CITY OF MADISON INTERDEPARTMENTAL CORRESPONDENCE

Subject:

1630 Adams Demolition Request

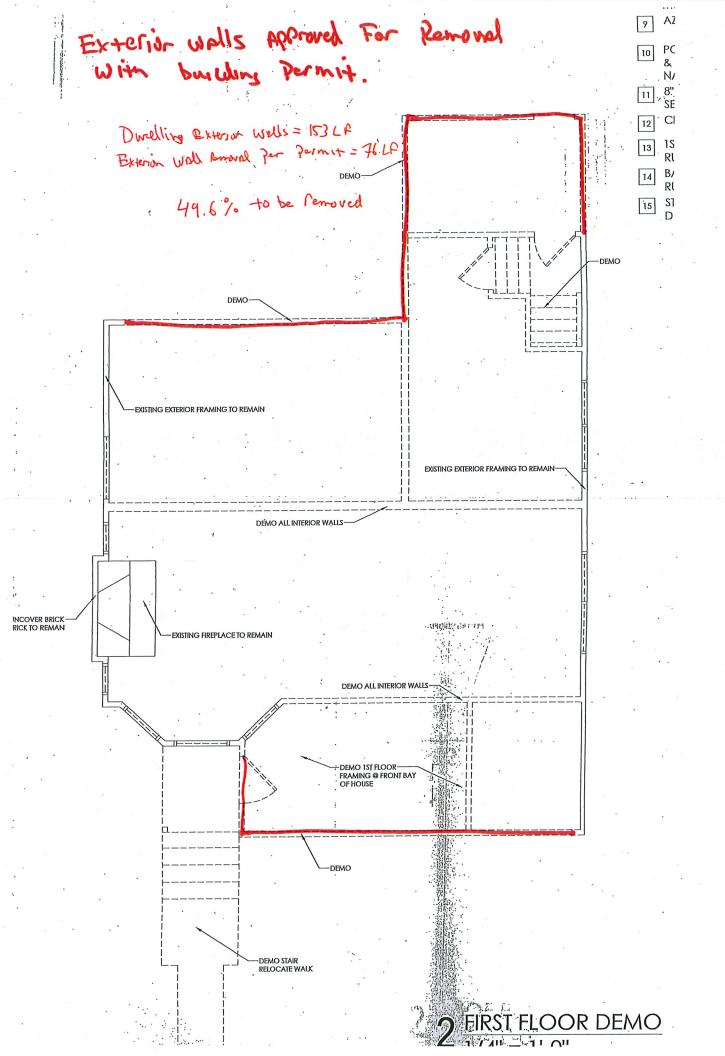
On 1/4/19, the area building inspector visited the site, and noticed what appeared to be more wall removal than allowed per the building permit. The additional wall removal appeared necessary due to extensive deterioration of the existing wall and sill plate, discovered as the walls and siding were opened to expose the framing. A code conference was conducted with the architect,

and attached is the plan submitted by the architect showing the extent of wall removal (titled "DEMO REVIEW 01/04/19). The calculation of walls removed is 62.7%. A "stop work" order was issued and the matter put on hold until the Plan Commission approves the demolition. An application for demolition approval was submitted on 1/22/19.

Revised building plans were submitted on 3/8/19 and these plans have been approved by Building Inspection Plan Review. These plans show all-new walls and sill plate on the existing foundation, in addition to the proposed addition, which appears unchanged.
